CITY OF SEGUIN & GUADALUPE COUNTY

30% SUBMITTAL

FEDERAL AID PROJECT
PROJECT NO.
CSJ: 0915-46-052
LIMITS FROM: SH 46
TO: SH 123

FOR WORK CONSISTING OF EXPANDING ROADWAY FROM 2 TO 4 LANES WITH RAISED MEDIAN OR CENTER TURN LANE. REALIGN CORDOVA ROAD AT SH 46. ADD SHARED USE PATHS.

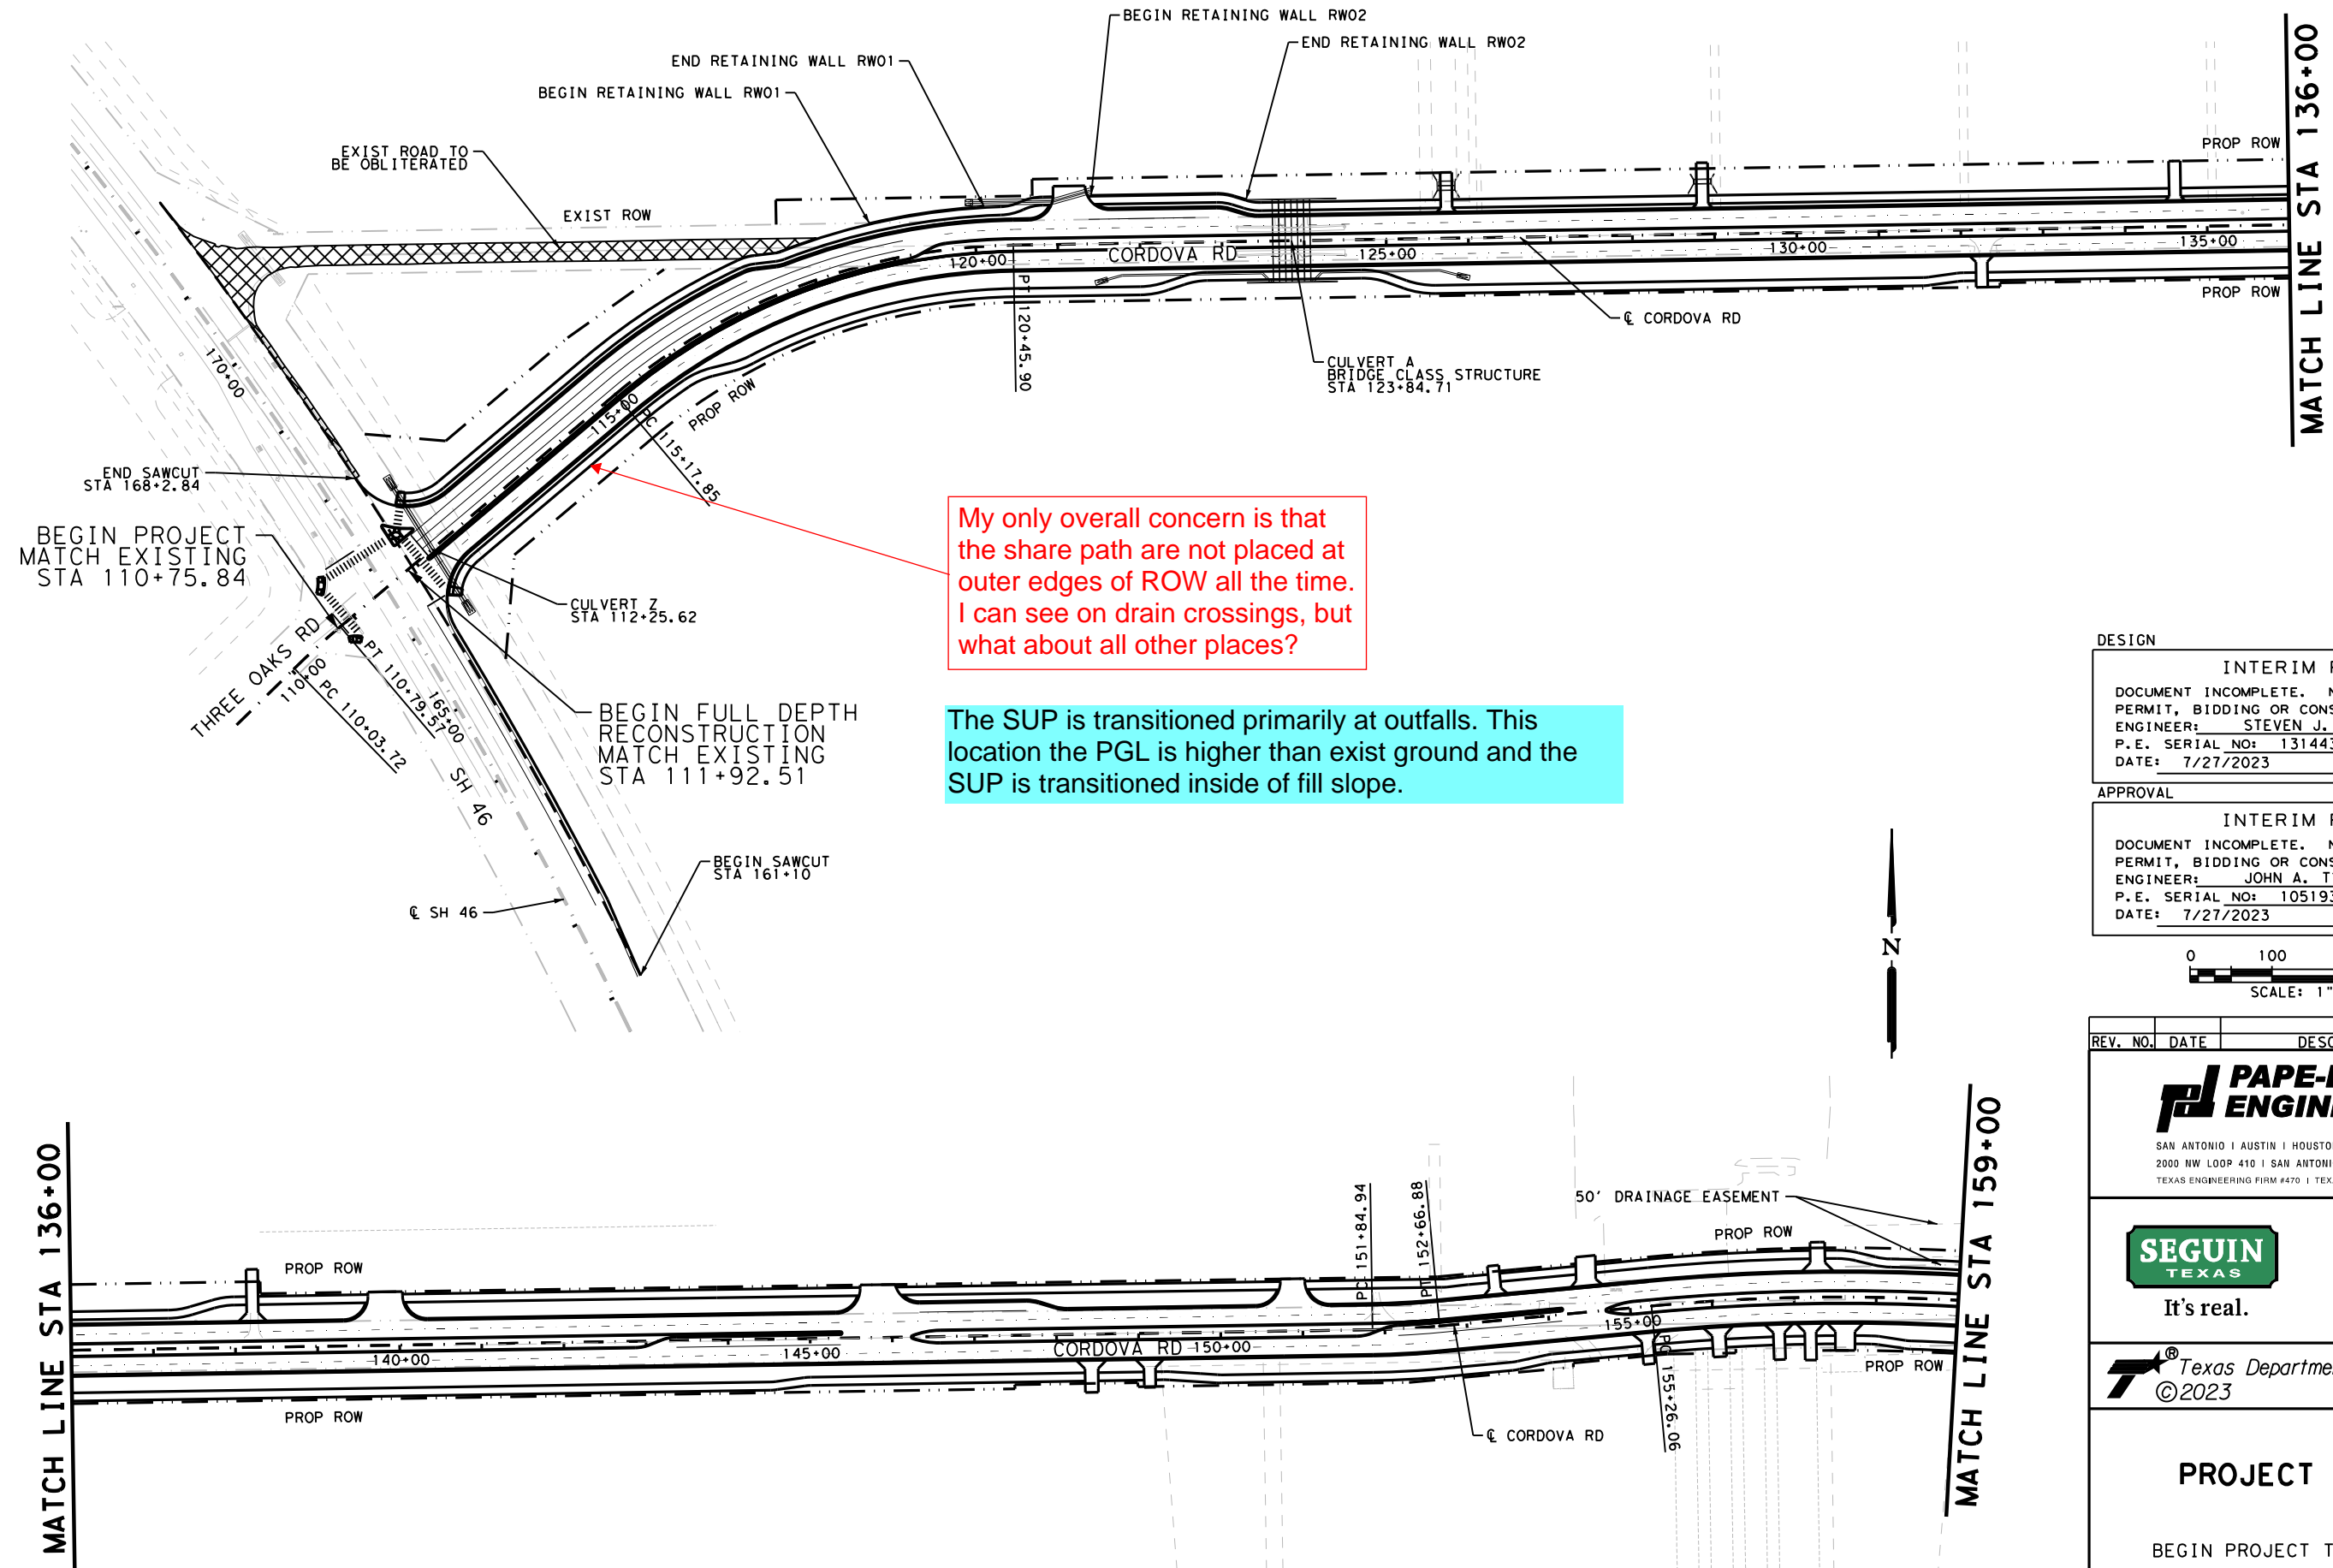
My only overall concern is that the share path are not placed at outer edges of ROW all the time. I can see on drain crossings, but what about all other places?
